ADDENDUM NO. 1

Reference: HVAC Upgrades – CDL Building
Uintah Basin ATC – Roosevelt, Utah
DFCM Project No. 10048250

ADDENDUM

DATE: August 30, 2010
PROJECT NO: 10230
PROJECT: UBATC AG Building Upgrade

SHEET M-101
MECHANICAL PLANS

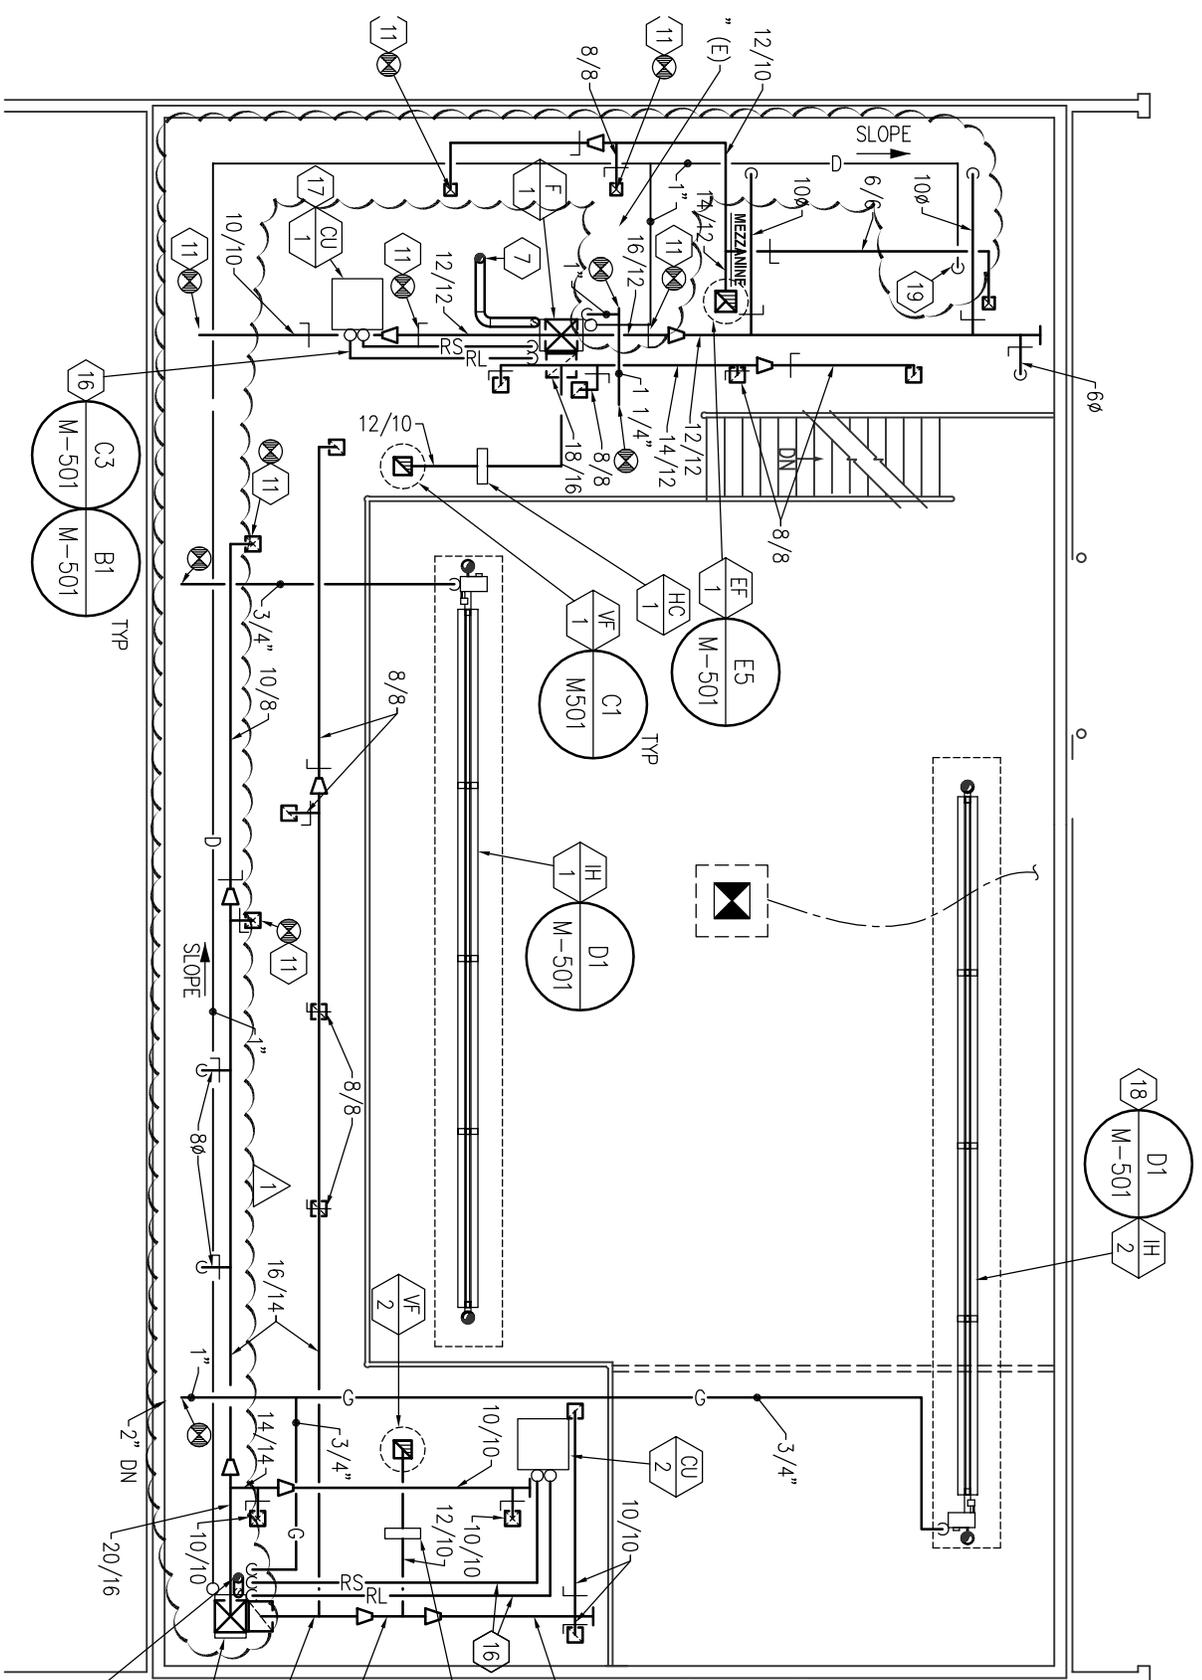
SHEET - M101

1. Add condensate 1" condensate drain lines for each furnace F-1 and F-2. See attached sheet for piping layout. Condensate pumps CP-1 and CP-2 are to serve furnace F-1 and F-2 respectively.
2. Keyed note 2: Furnace noted to be removed shall be salvaged and returned to the owner.
3. Diffuser and Grille Clarification: All diffusers & grilles depicted on the mechanical plan in bold shall be new. All diffusers and grilles shown in grey are existing to remain.

19 EXTEND FURNACE CONDENSATE LINE IN MEZZANINE SPACE TO JANITOR'S SINK. DROP LINE DOWN WALL & STUB OUT WITH AIR GAP ABOVE JANITOR'S SINK.
